Enclosed are comments on the January 1982 environmental assessment for the proposed Glen Canyon powerplant uprating. We wish to thank you for the opportunity to get involved in the preliminary review process, and hope you will find our analysis beneficial.

REVIEW OF THE ENVIRONMENTAL ASSESSMENT FOR
THE GLEN CANYON POWERPLANT UPRATING

April 30, 1982

FIGURE 1 CHANGES IN MONTHLY POWERPLANT
RELEASES : 1966-1981 ^{1/2}

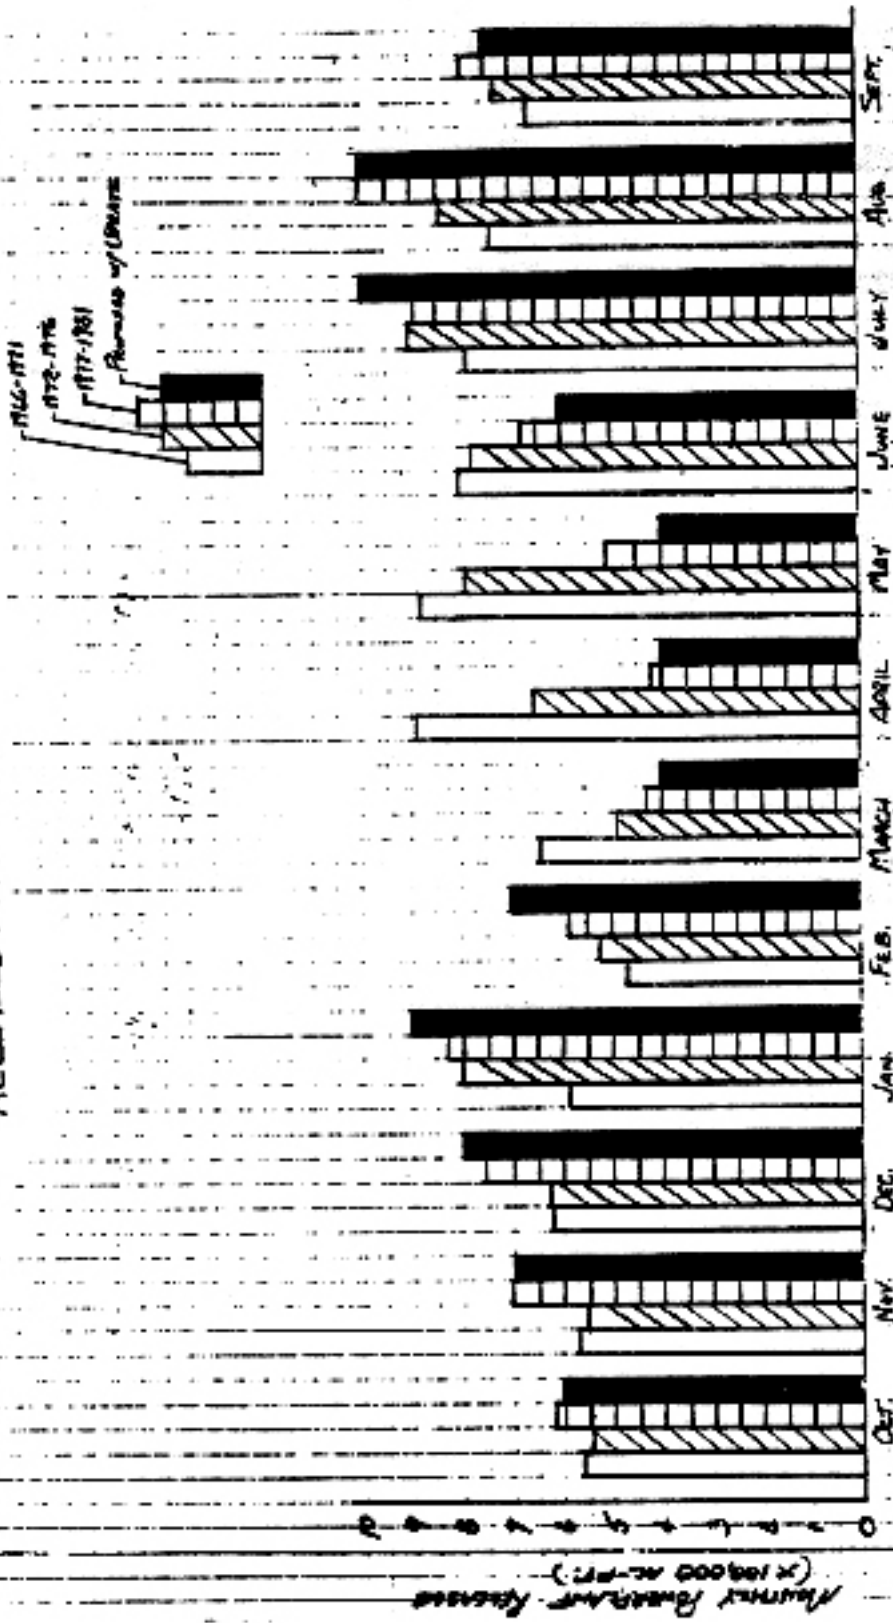
If uprating is implemented at Glen Canyon, the seasonal shift in reservoir releases will be accentuated. Monthly release volumes for post-uprating reservoir operation, as projected by the Bureau, are shown in row (B) of Table 1. Graphic comparison of the normalized monthly average releases and projected releases (row (B) of Table 1) appearing in Figure 1 indicate a major increased release requirement for July, and smaller potential increases for December and January. To supply these increases, current release volumes for October, April, May, and June would have to be reduced by varying amounts depending on reservoir inflow volumes and power marketing agreements. Reductions in current releases for these months would exacerbate the low flow problems presently experienced by river runners downstream from the Dam. A good deal of damage to the downstream riparian habitat from increased peaking operations and reallocation of seasonal flows may have already taken place.

Figure 5

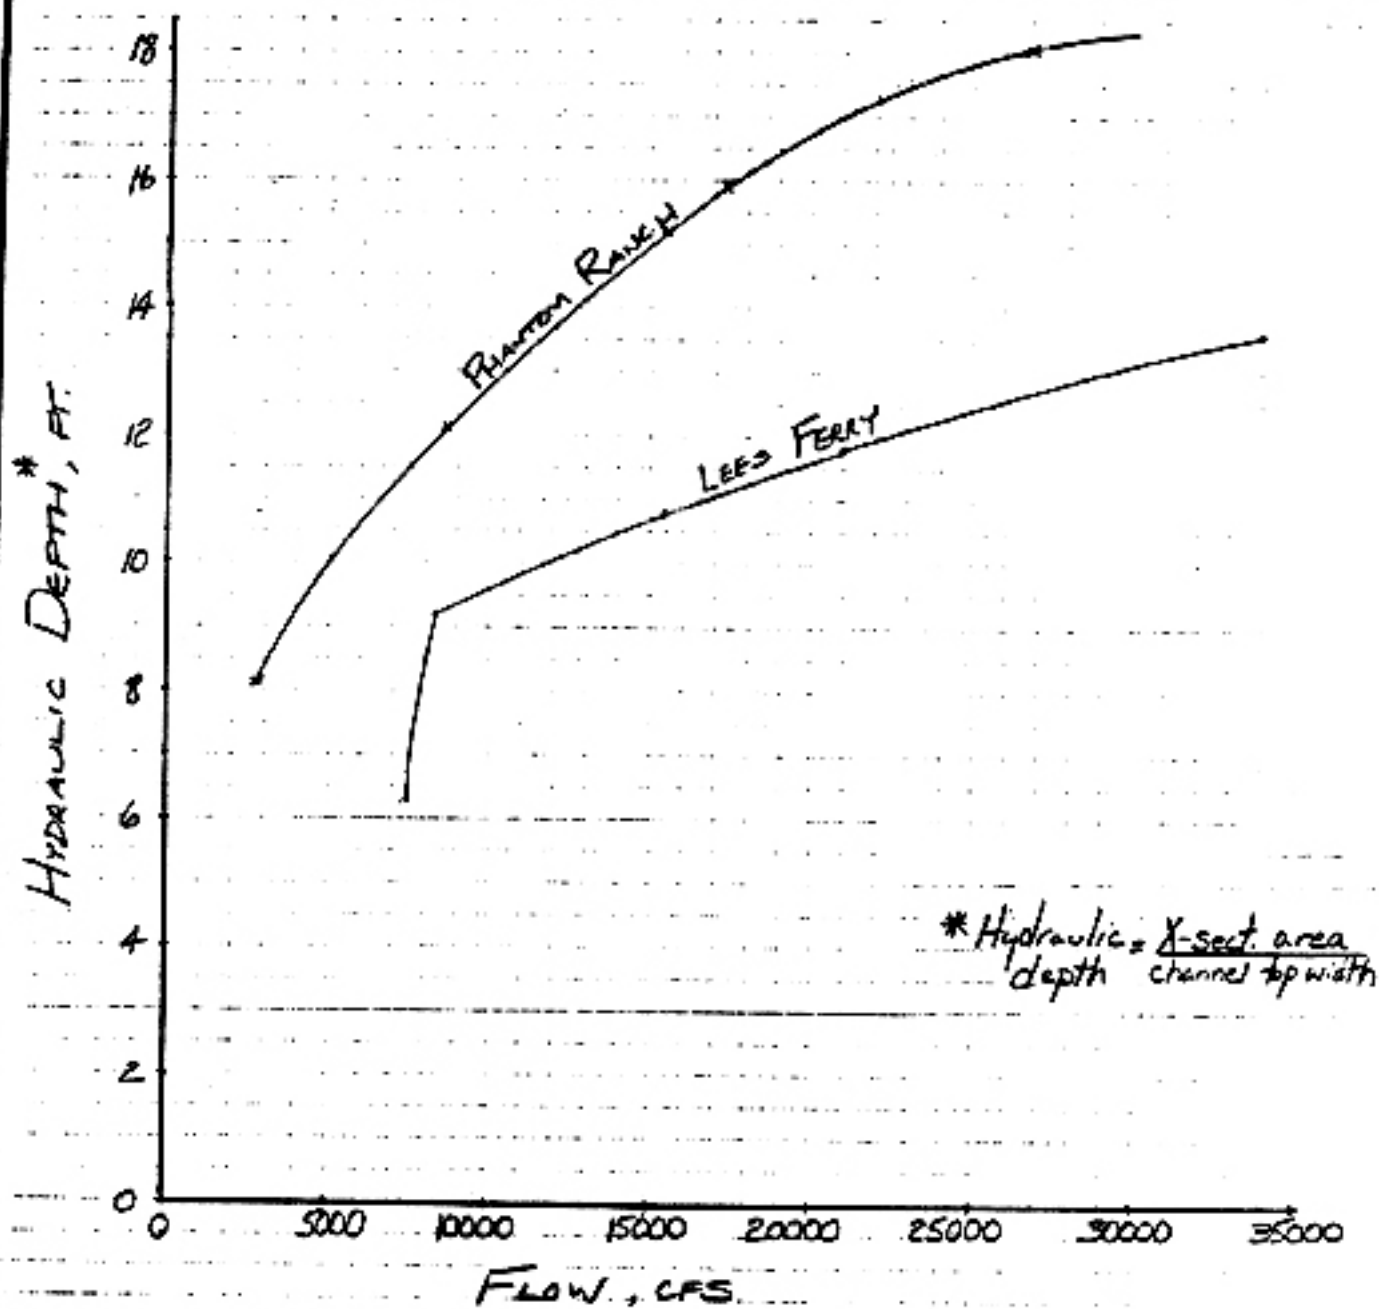
at Phantom Ranch; while the maximum rate of rise with the uprate is projected to be 1.9 feet/hour and 1.8 feet/hour at Lee's Ferry and Phantom Ranch respectively. On the other hand, the estimated maximum rate of river fall for no uprate and uprate conditions at Lee's Ferry would be 0.3 foot/hour and 1.8 feet/hour, while the rate of river fall at Phantom Ranch with and without uprating would be the same. The steepness of the rates of rise and fall shown in Figure 6 for the post-uprate condition at Lee's Ferry is a reflection of the narrowness of the river channel at low flows as indicated by the graph in Figure 5.
